Appendix to Summary Staff Report, 15091 Penrod, 5/8/26

Staff has recompiled/ reformatted the applicant's submitted materials and photos for clarity and presents them in the following appendix.

Applicant's Side A. Front of house, or east. Pink Xs mark features to be replaced. Blue outlines mark features to be preserved in place.

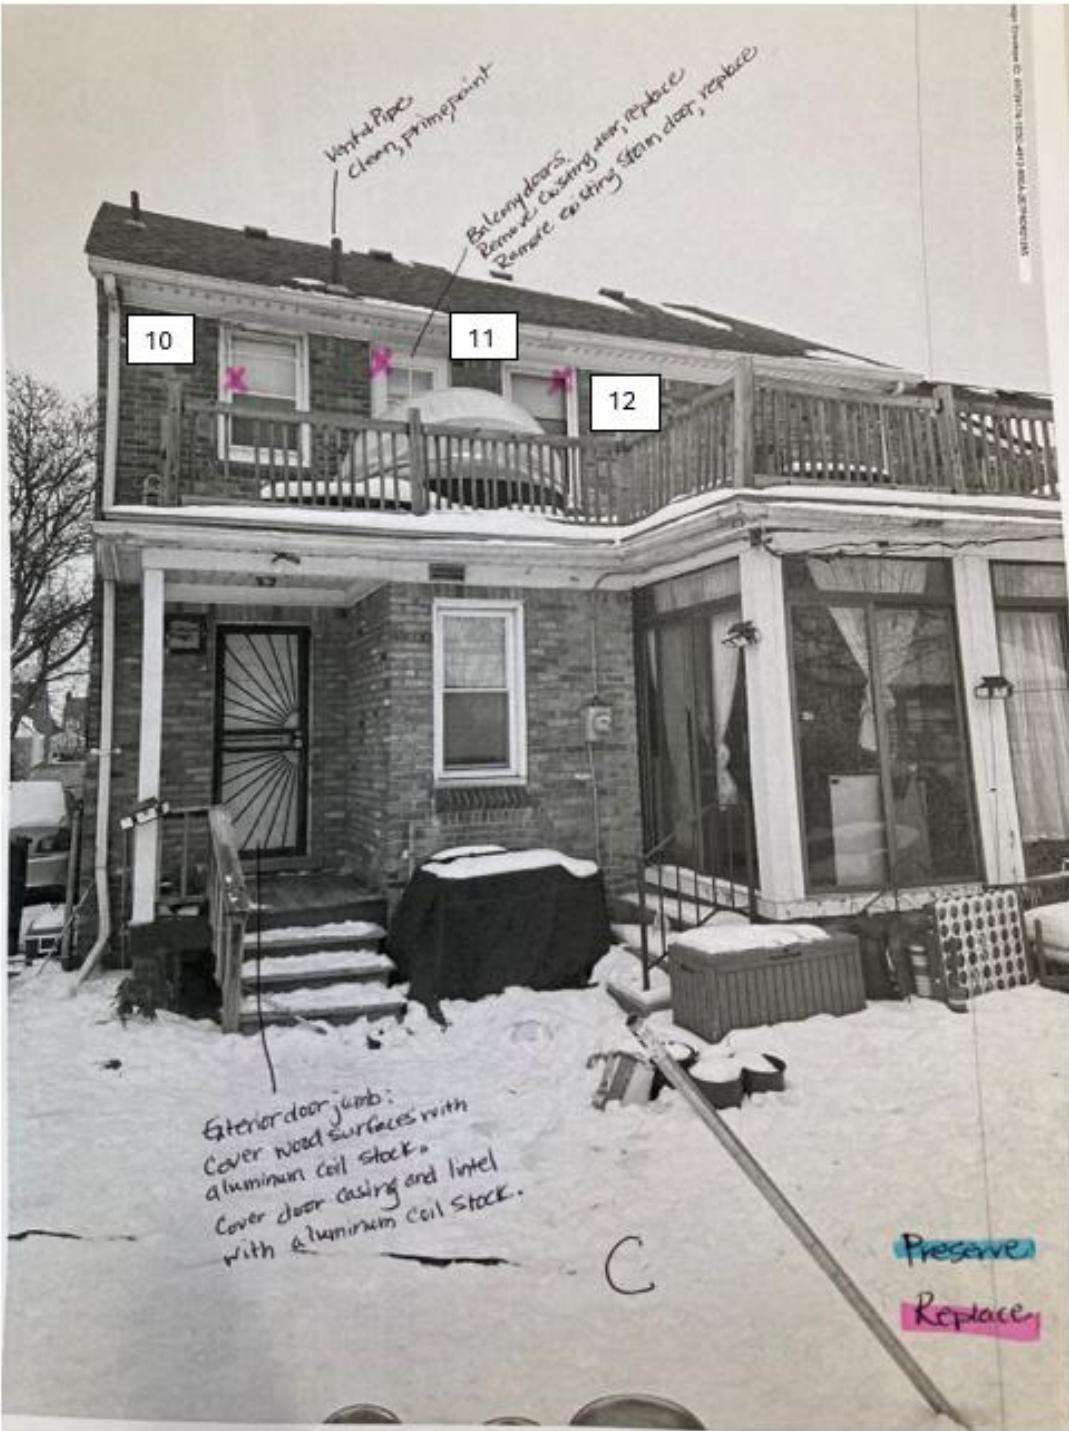
These photos below were provided by the applicant and marked up by staff to help identify the windows proposed for replacement. The windows and door marked with pink Xs are proposed for replacement. The features outlined in pale blue were identified in the scope of work as remaining in place. (There are several windows that are fixed in place and likely historic, and these fixed windows are not proposed for replacement in this application.) The applicant confirmed that staff's understanding of the windows and doors proposed for replacement is correct. Staff then numbered the items proposed for replacement on these photos.

Applicant's side D, house's north side.

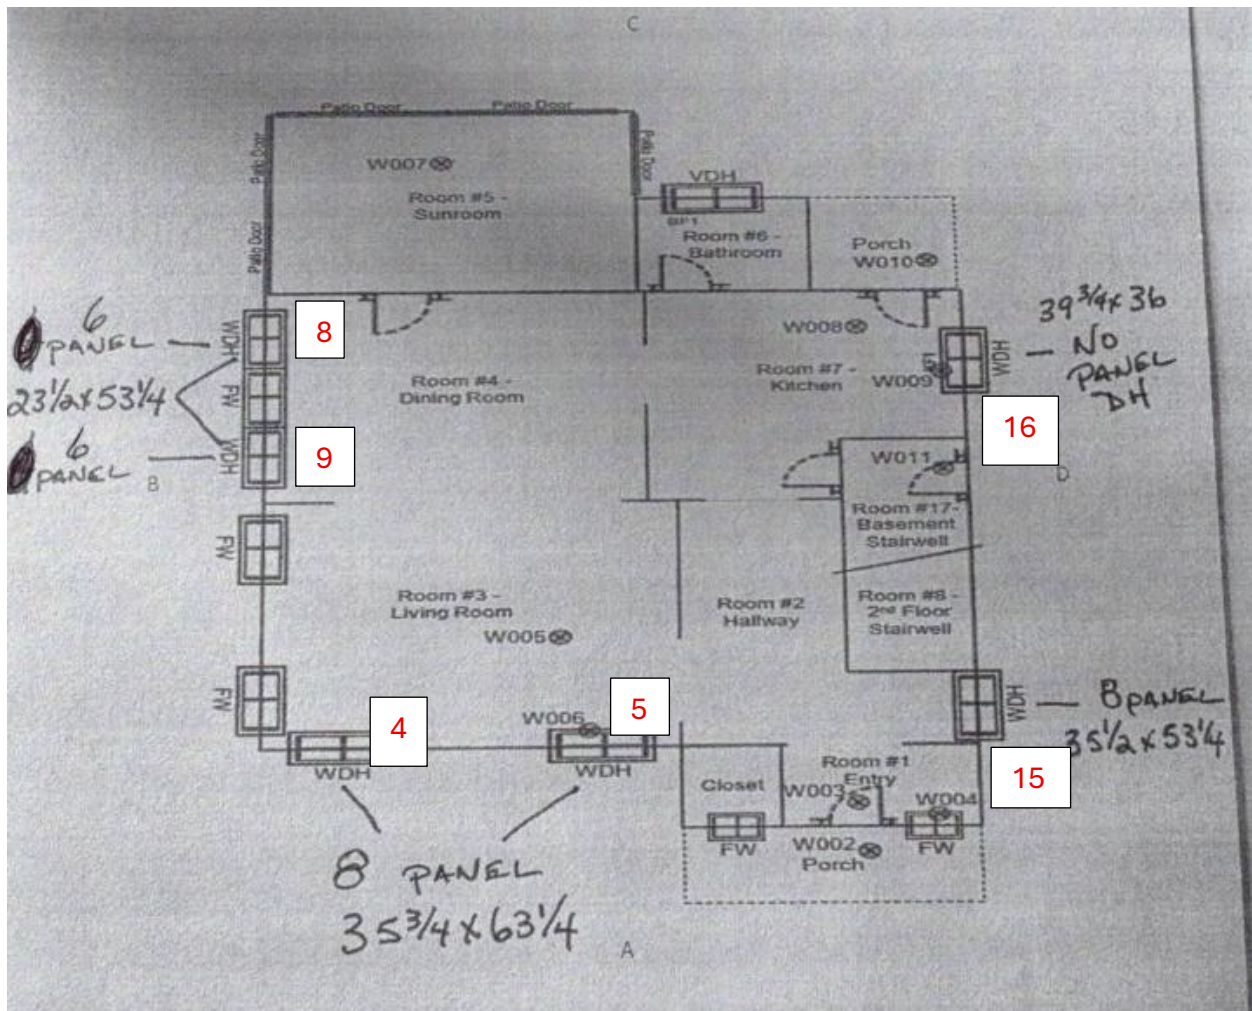
The applicant provided floor plans of the house with the window configurations identified (below) and photos of windows and doors to show conditions. Staff numbered the windows and door on the floor plans in red to correspond with the photos of the house staff marked up (above).

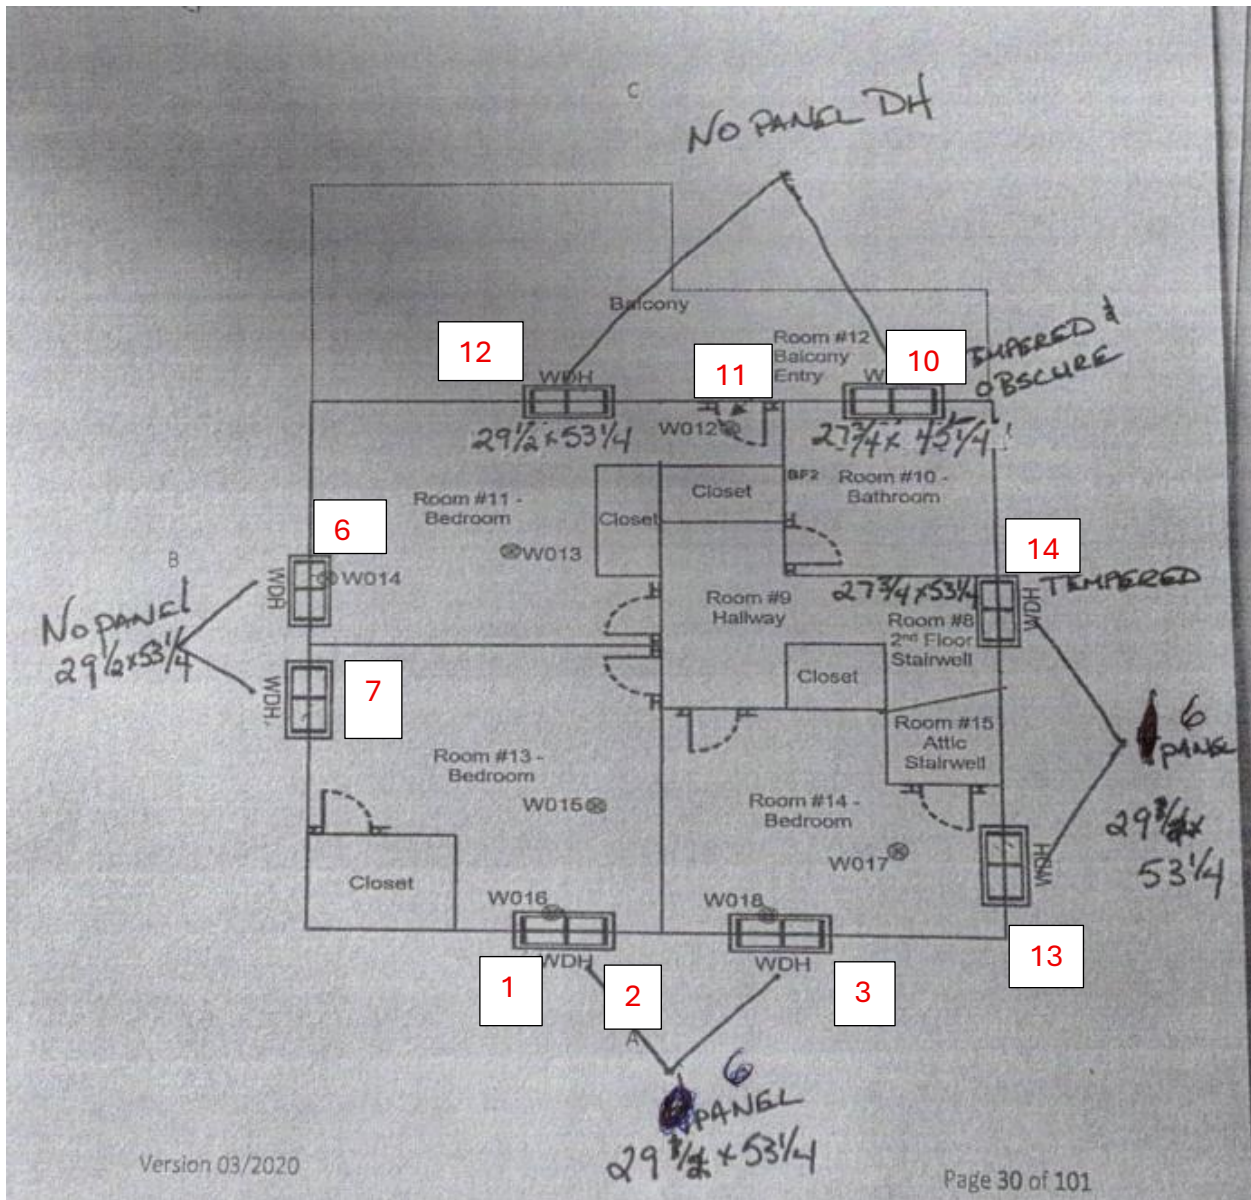
First-floor floor plan. Applicant provided this plan to accompany their draft window order. Both the floor plans and the window order were posted on the meeting webpage. Staff numbered the windows and door on the floor plans in red to correspond with the photos of the house staff marked up (above). (The symbols of the x in a circle scattered around the floor plan mark the locations where paint samples were taken.)

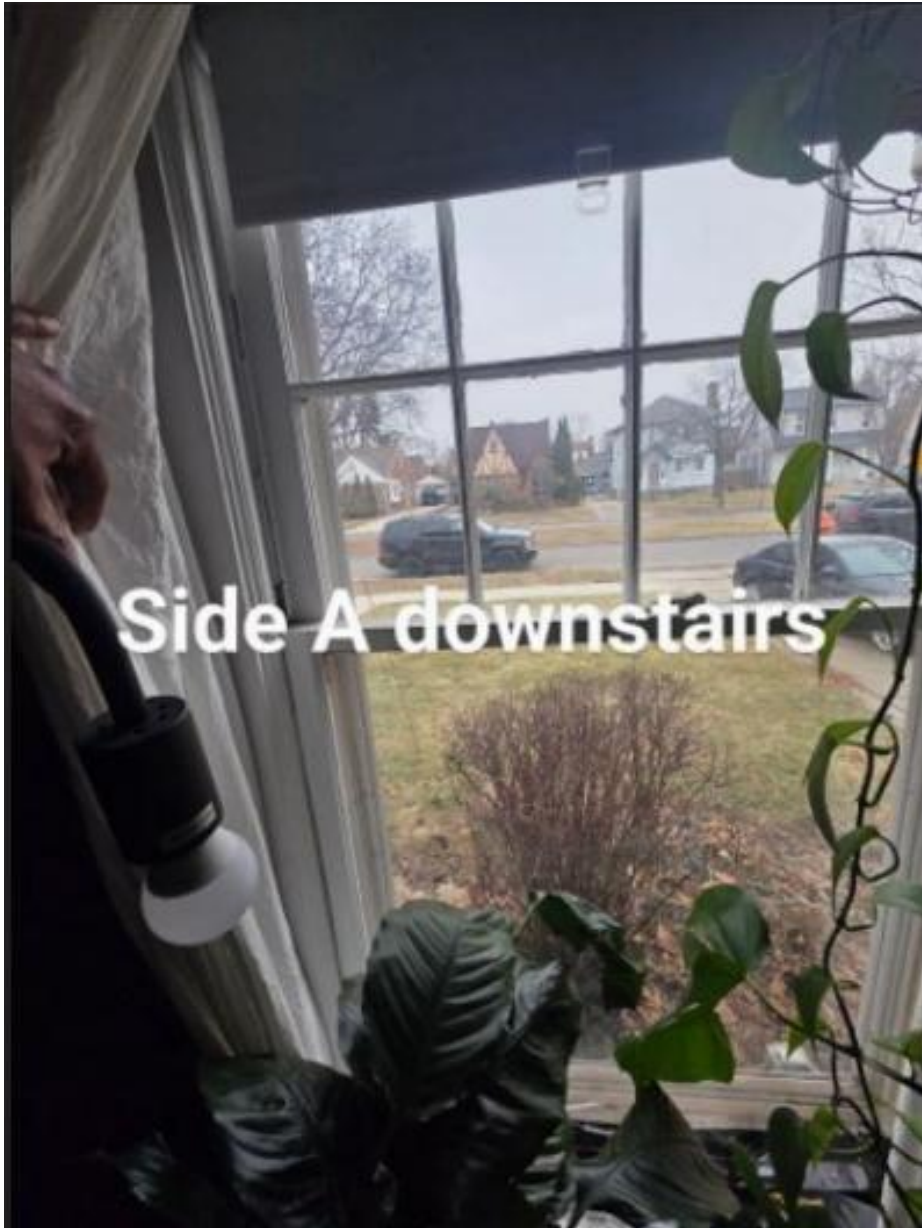
*Higher-resolution duplicate image of above. This image is from Cycle 3 application materials and is the window above the front door (staff's **Window 3**). Based on the floor plan, the applicant numbered this window "Bedroom 11C," but staff thinks this label is inaccurate because in the application materials, the porch light over the front door and below this window can be seen.*

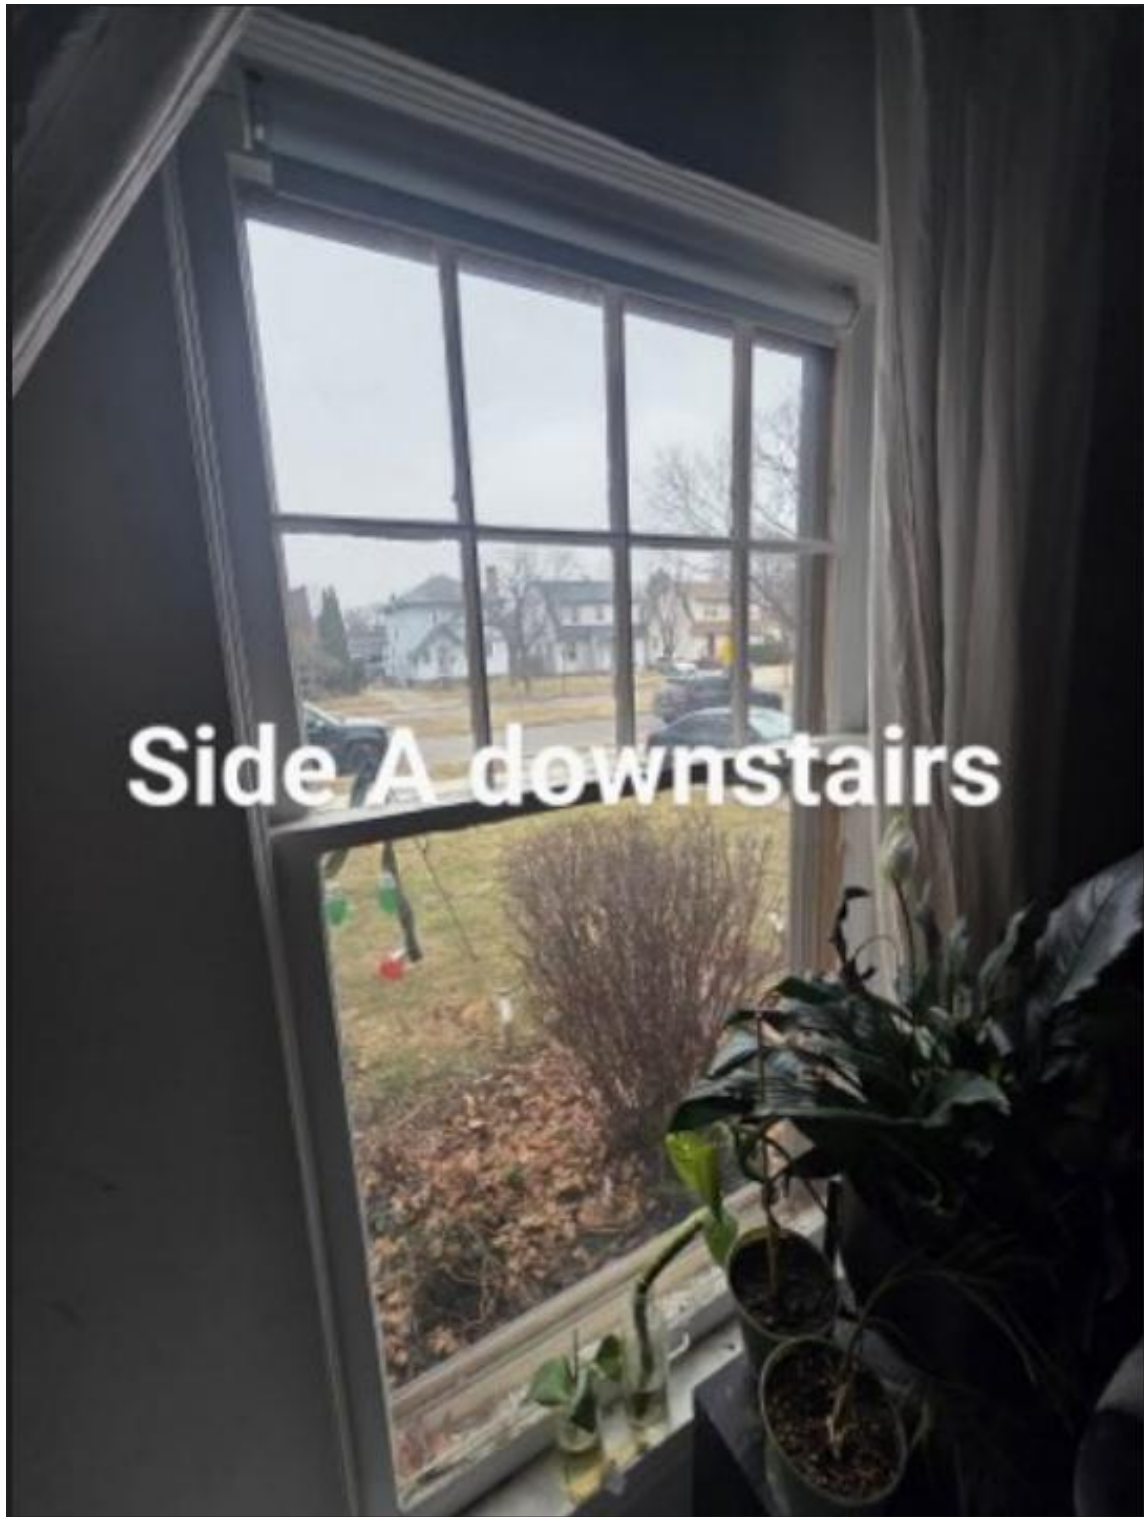
*Staff identifies this as **Window 4**, on the front of the house. It is one of the cottage-style windows.*

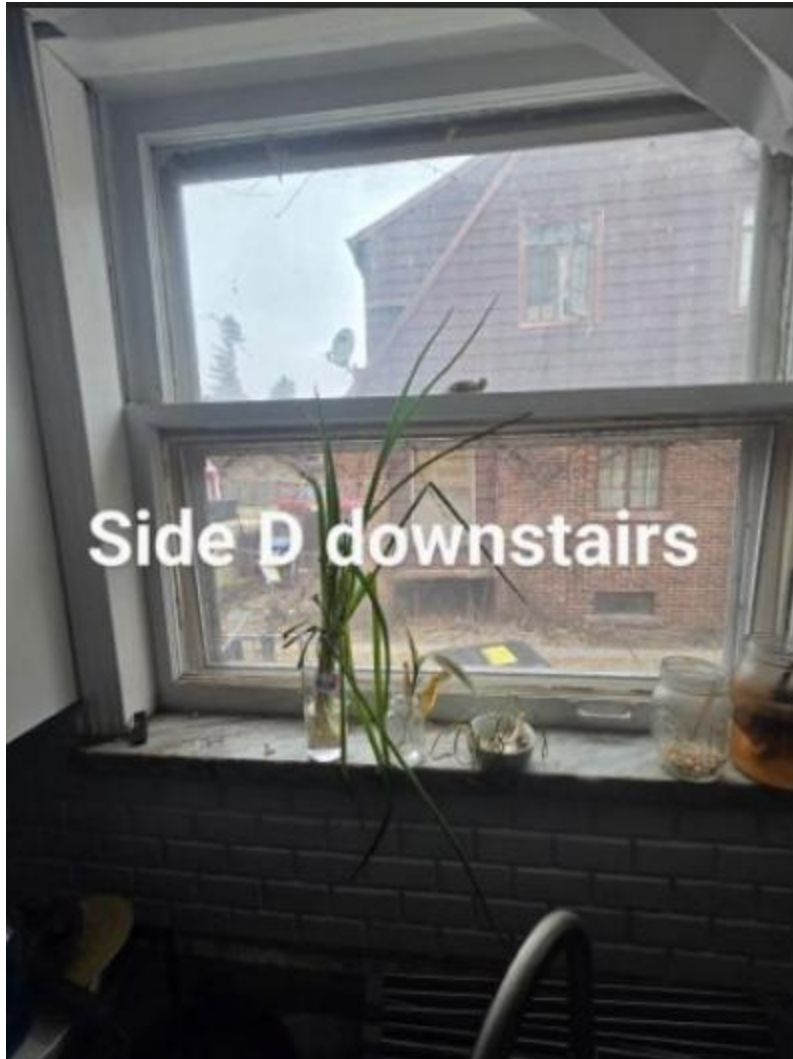
*“Side D Downstairs” would correspond with staff’s Window 15, but the muntin configuration here indicates this window is actually upstairs. In Cycle 3 application materials, the applicant identified this window as “Bedroom 14D,” which would correspond with staff’s Window 13. Staff believes, based on the ivy and the bright white mortar or caulk spot to the upper left, that this could be **Window 14.***

Rear Balcony Doors:

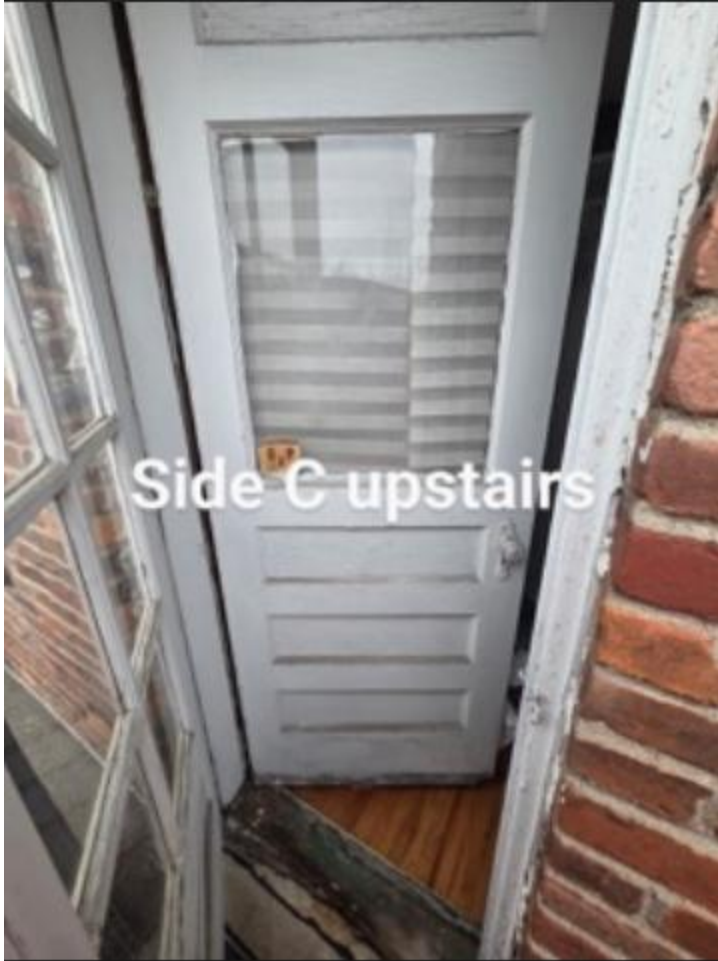
Rear balcony storm door interior and entry door exterior. Some deterioration can be seen in the wood below the glass on the storm door. Staff identified these doors as "11."
